**KWM-380 TRANSCEIVER (622-5093-101)
HF-380 TRANSCEIVER (622-3580-101)
RECEIVER-EXCITER CIRCUIT CARD A3 (638-6908-001)**

SERVICE BULLETIN NO 1

PRODUCT IMPROVEMENT

P/O Receiver/Exciter Circuit Card A3
Figure 1

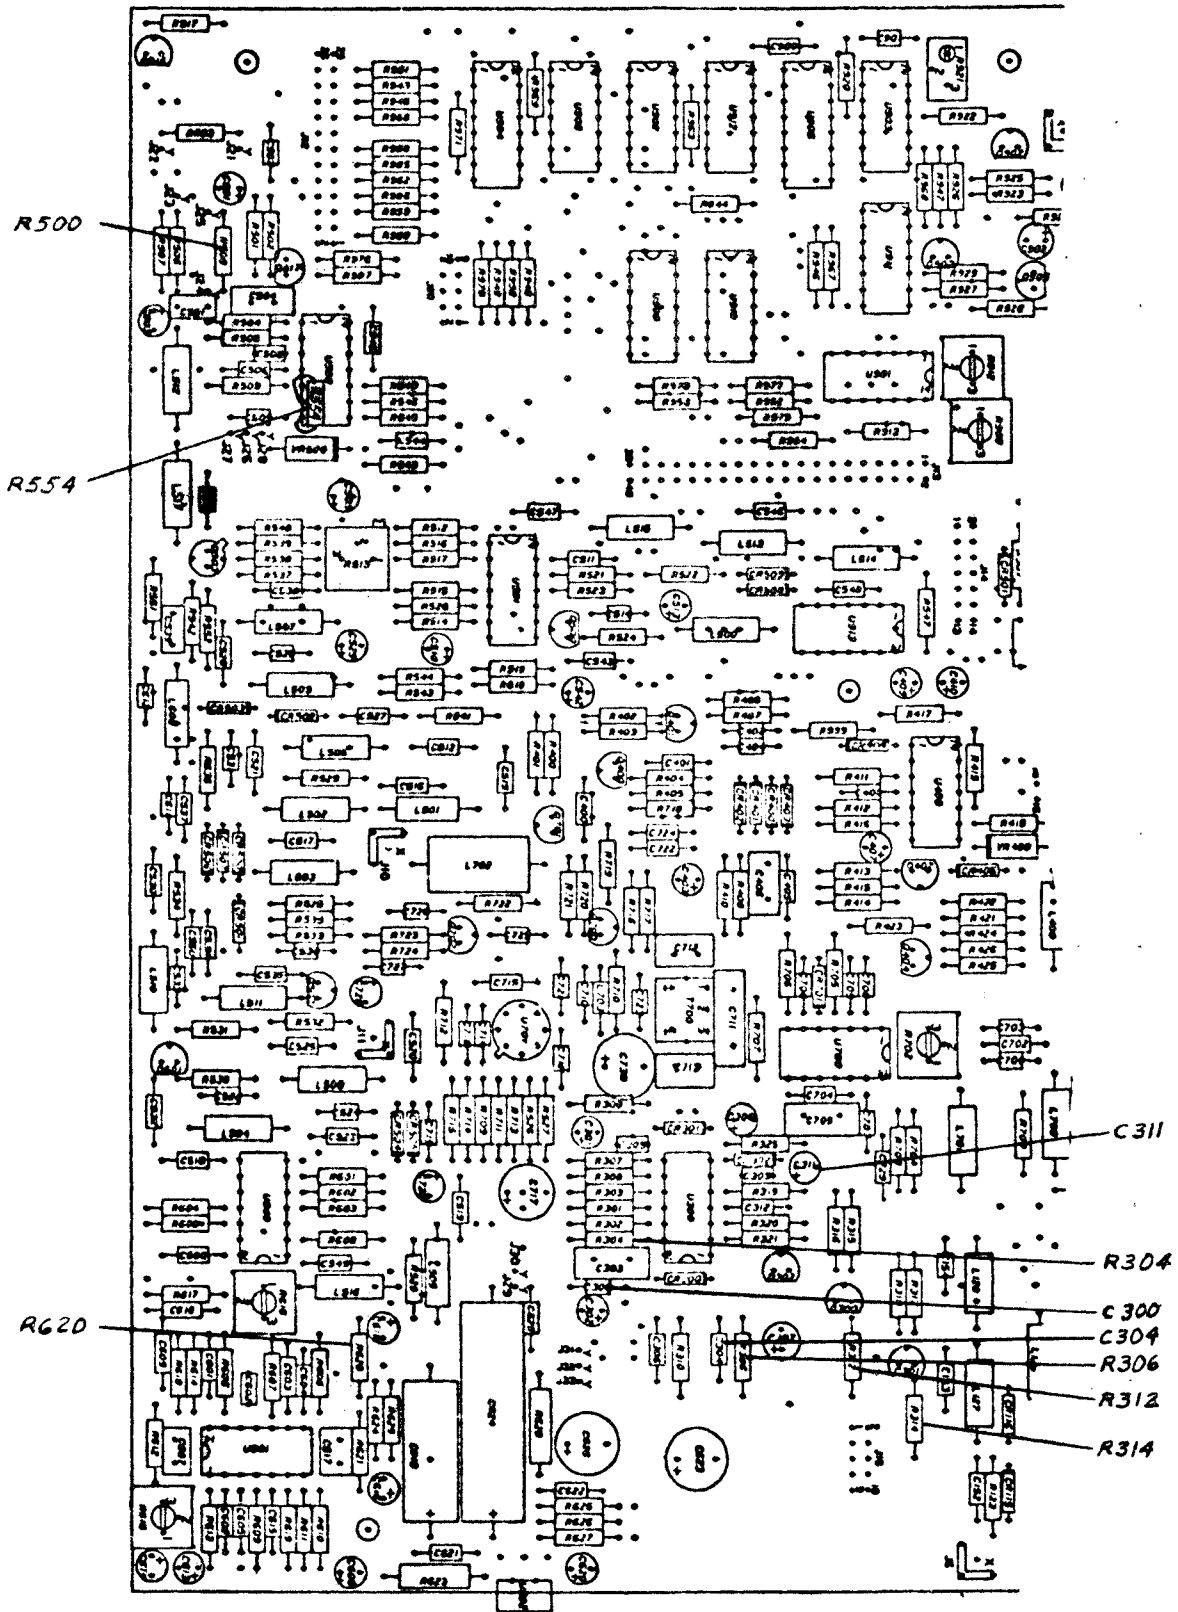
1. Mic termination is changed from 270-Ω to 3.3-k Ω to allow either a low- or high-impedance mic to be used.
2. Mic gain is increased by approximately 18 dB.
3. A greater range of adjustment for VOX sensitivity is provided.
4. Minimum VOX delay time is decreased to less than 50 ms to allow faster semibreak in CW operation.
5. Preemphasis to VOX preamplification is added to improve SSB VOX operation.
6. Line audio (600 Ω) output level is increased to ensure at least -10-dBm output.

- C. Remove 100-k Ω resistor R554 and replace it with a 1-M Ω resistor (745-2449-000).
- D. Remove 270- Ω resistor R500 and replace it with a 3.3-k Ω resistor (745-0767-000).

- E. Remove 33-k Ω resistor R620 and replace it with an 18-k Ω resistor (745-0794-000).
- F. Remove 1- μ F capacitor C311 and replace it with a 0.22- μ F capacitor (184-9102-310).

- G. Remove 1-M Ω resistor R304 and replace it with a 100-k Ω resistor (745-0821-000).
- H. Remove 0.01- μ F capacitor C300 and replace it with a 1000-pF capacitor (913-3281-270).

- I. Remove 0.1- μ F capacitor C304 and replace it with a 4.7- μ F capacitor (184-9102-390). The negative lead of the capacitor should be connected to the hole on the left.

- J. Remove 1-k Ω resistor R306 and replace it with a 100- Ω resistor (745-0713-000).
- K. Remove 47-k Ω resistors R312 and R314 and replace them with 10-k Ω resistors (745-0785-000).
